**PLANNING APPROVAL &
SUBDIVISION STAFF REPORT****Date: October 2, 2014****NAME**

Knollwood Subdivision

Planning Approval to allow a 150' cell tower in a B-2, Neighborhood Business District, and Subdivision approval to create two legal lots of record from an existing lot of record.

1
C-4 TOWER ELEVATION
SCALE: 1" = 20'

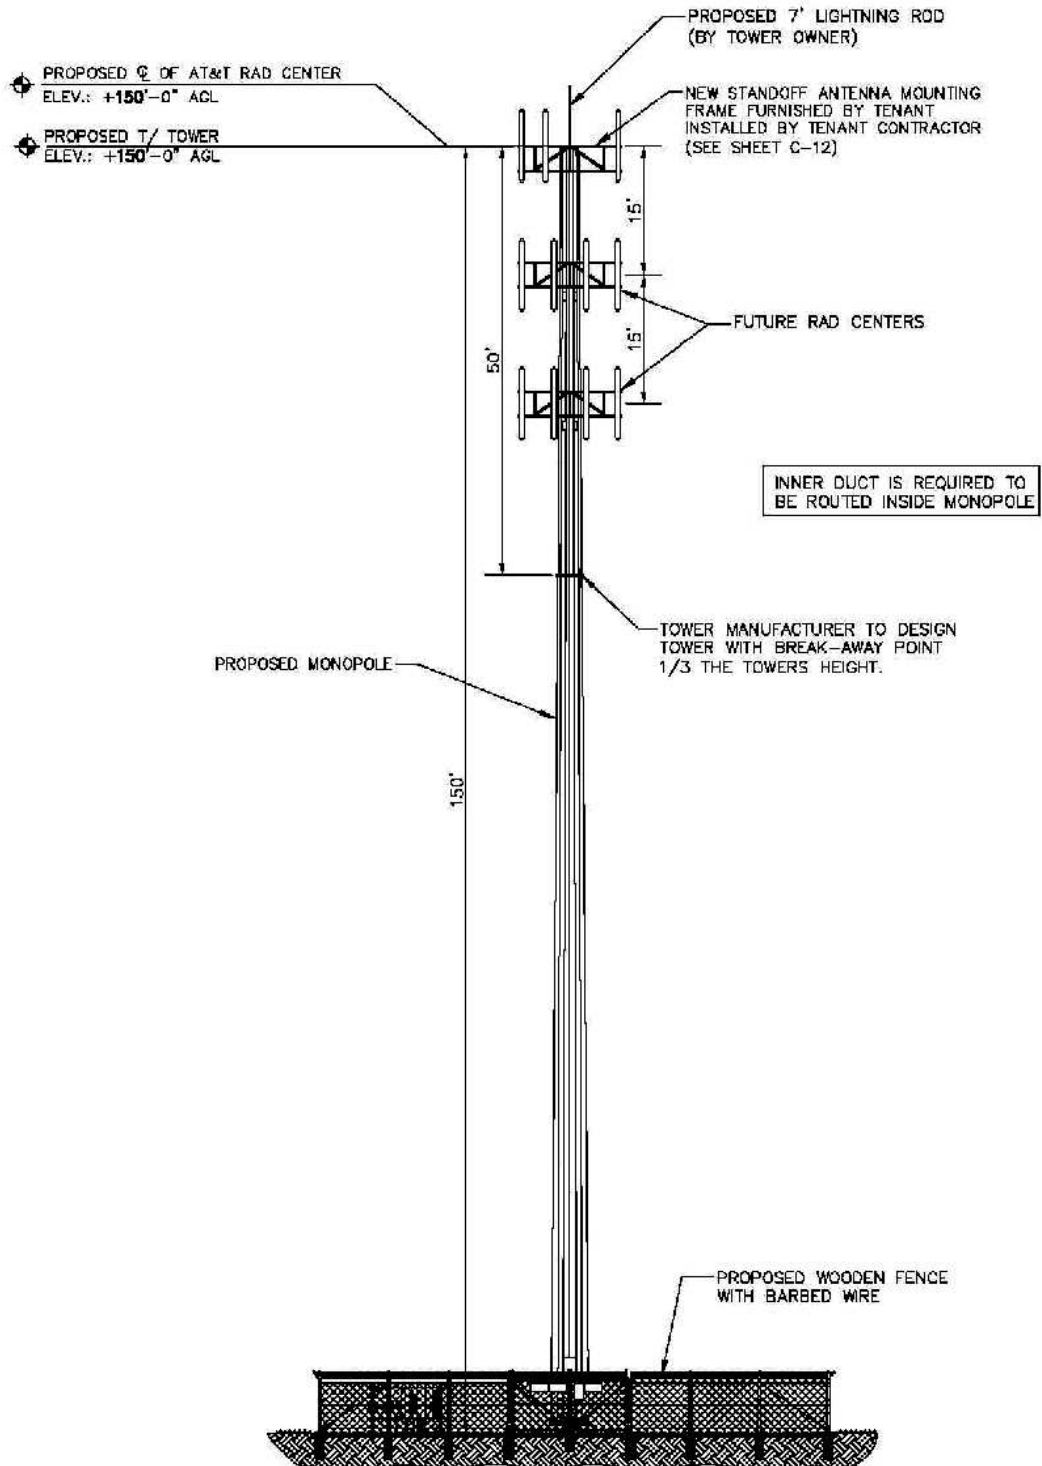
It should be noted that the tower elevation drawing indicates the top antenna segments to extend above the proposed 150' elevation and the lightning rod to extend 7' above the top of the tower to 157' above grade. The over-all height of the communications equipment/structure (antennae/lightning rod) should not extend above the proposed 150' elevation. If design constraints do not allow the lowering of the antennae, this application should be revised to allow the required height above 150'. The Height Variance request should correspond to whatever over-all height is determined to be required.

- 1) revision of the tower height drawings to indicate the maximum height of the tower/antennae/lightning rod to not exceed 150' over-all height, or the revision of this application to allow the required over-all height for adequate communications operation;
